Amendments to the Drawings

REMARKS

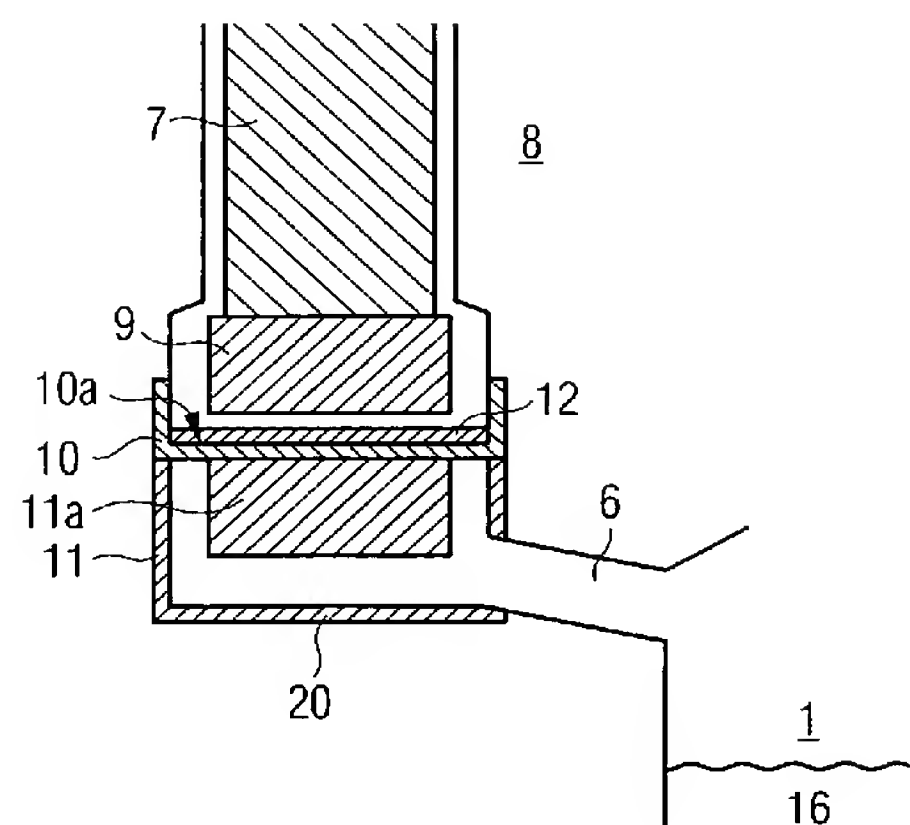
Please replace Fig. 1 of the application with the amended figure reflected on the attached Replacement Sheet. Fig. 1 is amended to include superconducting windings in the form of a labeled representation, i.e., a labeled rectangular box.

The drawings are objected to as not showing the superconducting windings recited in claim 7. Superconducting windings within a cryostat were generally well-known in the art at the time of the invention and their detailed illustration is not essential to proper understanding of the invention. Accordingly, consistent with 37 C.F.R. § 1.83(a), it is proposed to amend Fig. 1 so that the superconducting windings are “illustrated in the drawing in the form of ... a labeled representation (e.g., a labeled rectangular box).” It should be recognized that this amended figure includes a labeled rectangular box that represents the well-known superconducting windings within a cryostat, but does not necessarily reflect the actual geometry of such an arrangement, which is not required by 37 C.F.R. § 1.83(a). Thus, withdrawal of the objection to the drawings is respectfully requested.
